19 June 2014
Ref: 84/2014

OXFORD FALLS CHILD CARE CENTRE

SP 1

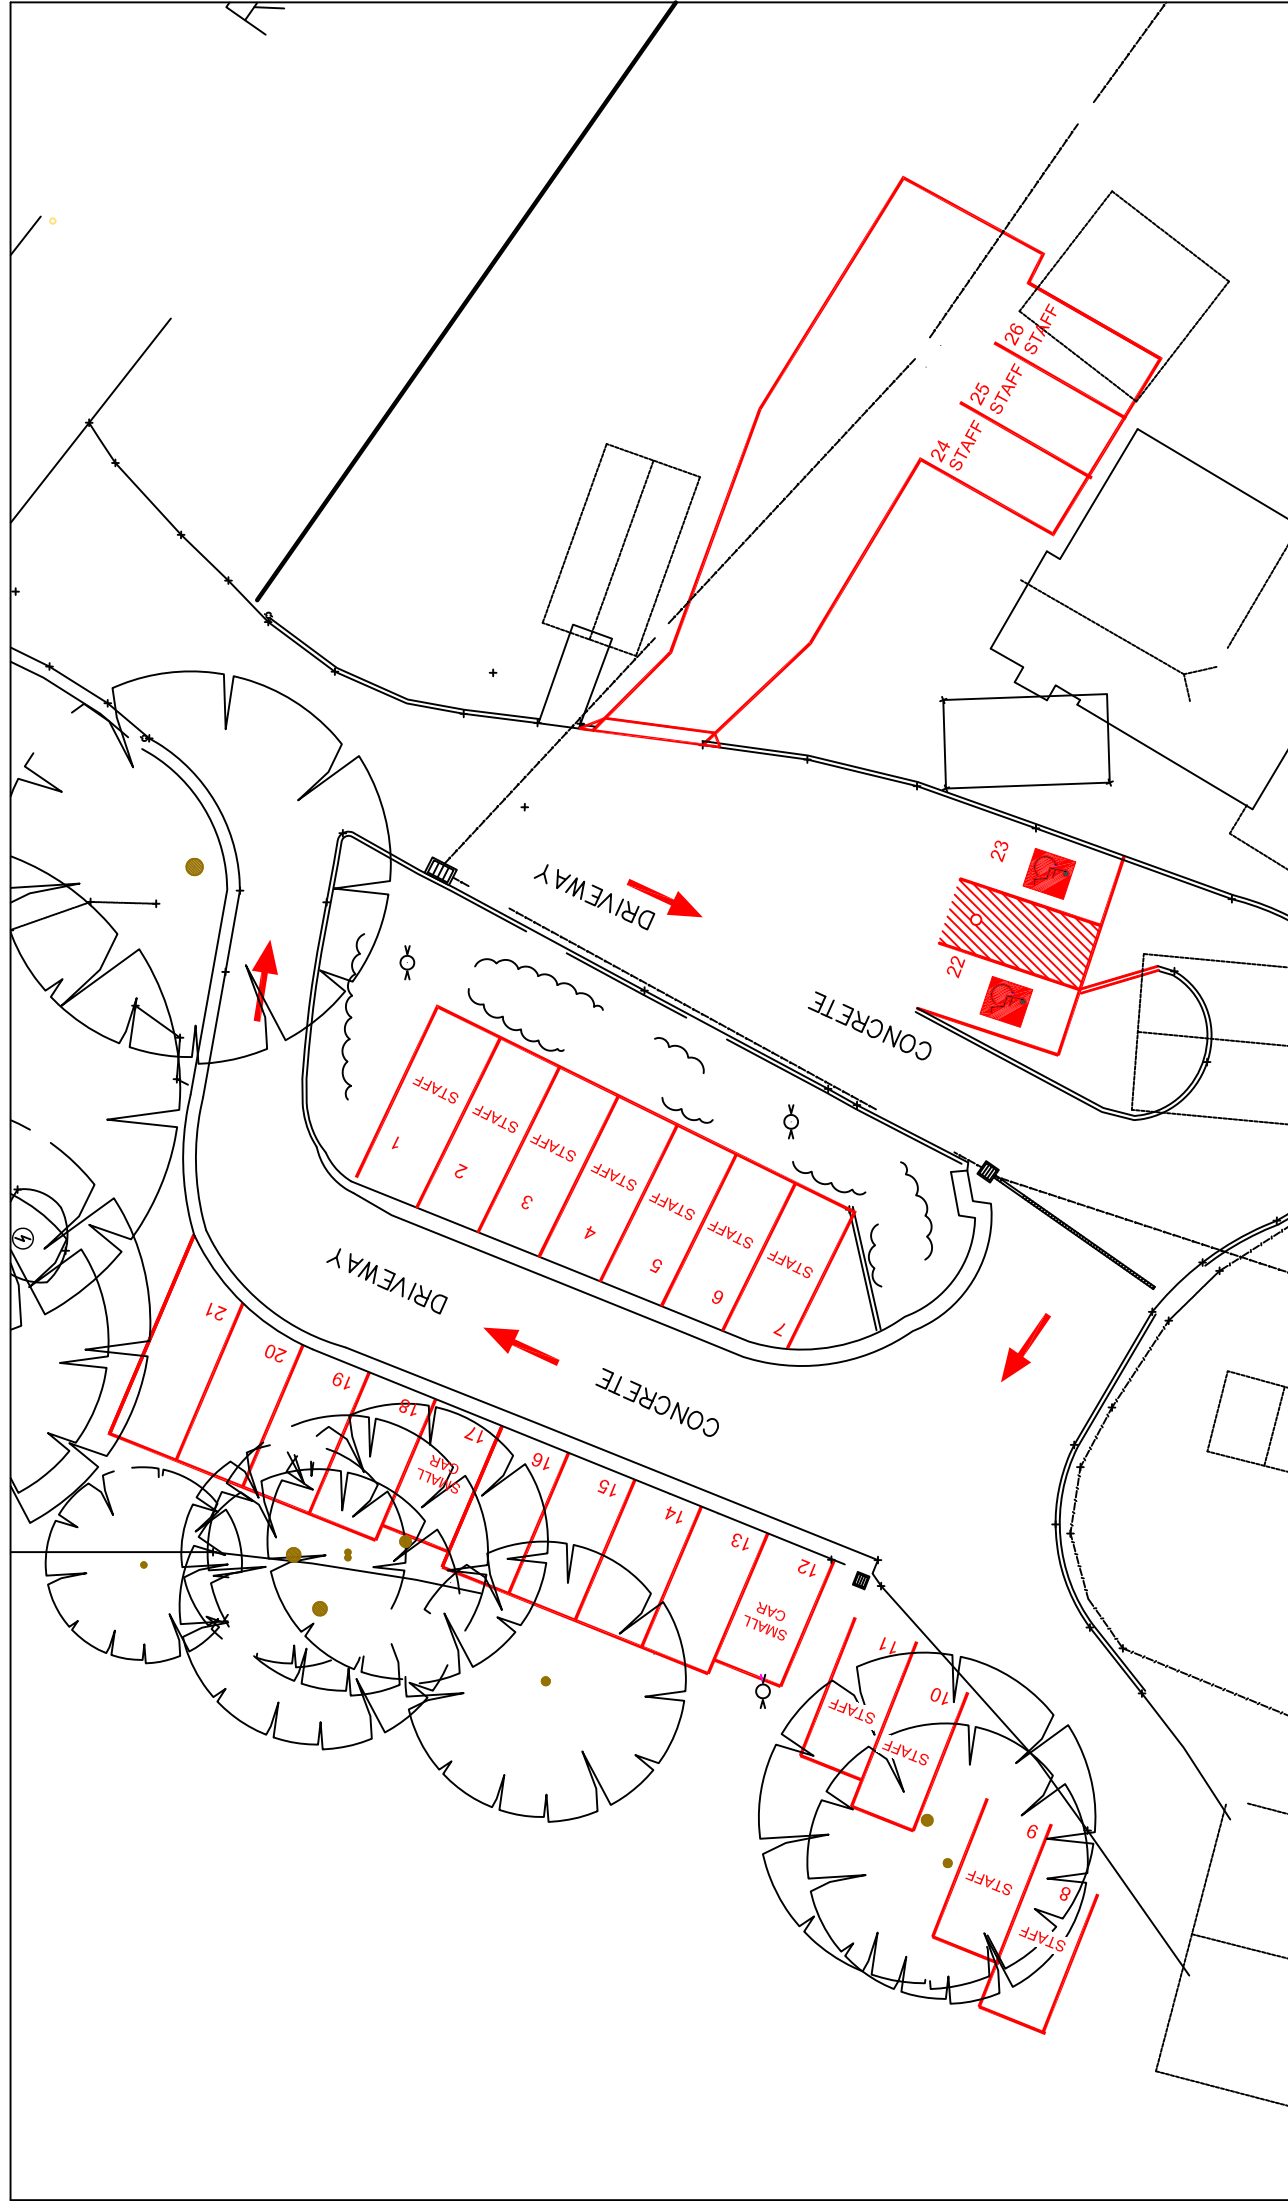
I have assessed the revised plan for car parking for the centre having regard for the site circumstances and the design criteria of the Australian Standards. It is my assessment this proposed layout complies with the requirements of AS2890.1 and 6.

It is also my assessment that there will be quite adequate manoeuvring available for cars using these parking spaces and that there will not be any adverse traffic or parking implications.
